# FREDERICK COUNTY PLANNING COMMISSION

**TITLE:** Middletown Valley Estates, Lots 6A and 6B

**FILE NUMBER:** S-578, AP 14255 (APFO N/A, FRO 14256)

**REQUEST:** Combined Preliminary/Final Plat Approval

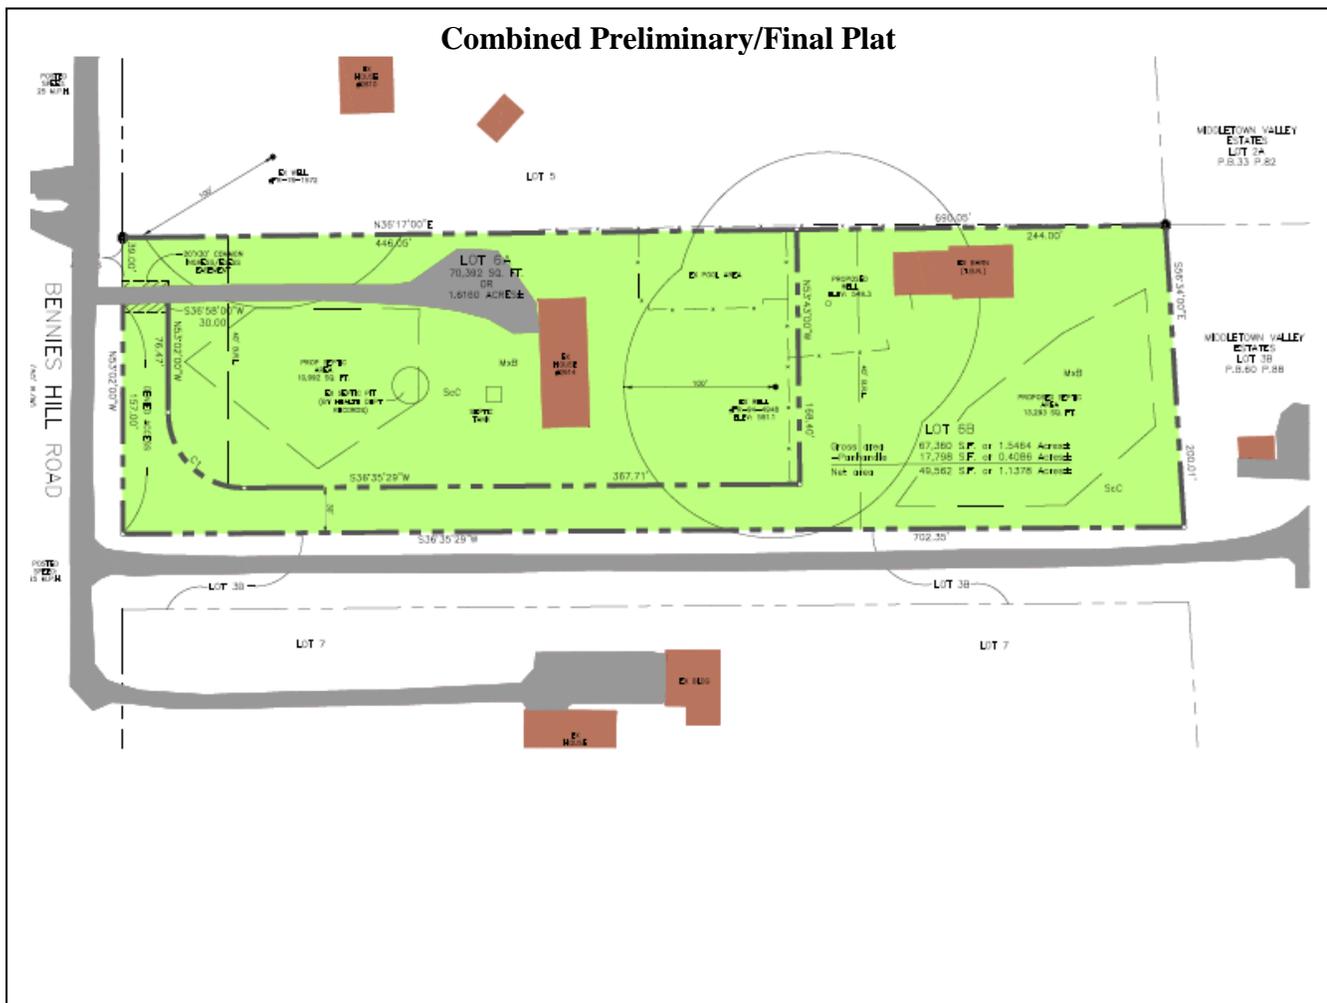
The lot will access Bennies Hill Road, which is 670 feet from MD 17 (Burkittsville Road). Bennies Hill Road is 20 feet wide for the first 360 feet from MD 17. The remaining 310 feet between the 20 foot wide road section and the driveway serving Lot 6 is 18 feet wide, which does not meet the minimum 20 foot wide paved road surface requirement.

Staff does not object to the approval of this single new lot with the current travelway width. The distance between the lot and MD 17 is only 670 feet, and more than half of this distance meets the 20 foot wide travelway requirement. The remaining 310 feet falls short by only 2 feet, and the 18 foot wide section is wider than the travelway width requirement for minor subdivisions (16 feet).
